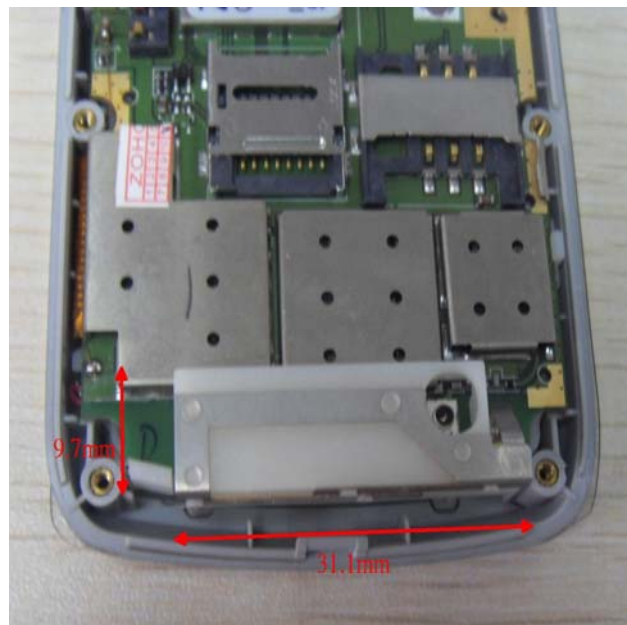
6. Scan resolution: the area and zoom scan resolutions described may not be sufficient to provide antenna positions and hot spots info; need further clarification on impact to measurement uncertainty budget and impact on the interpolation and extrapolation algorithms used by the SAR system.

Area scan is 6x6x1, step size 12mm, the scan area is 72x72 mm.

Room scan is 5x5x1, step size 8mm, the scan area is 40x40 mm.

Antenna position and antenna size information are added to the SAR test report.
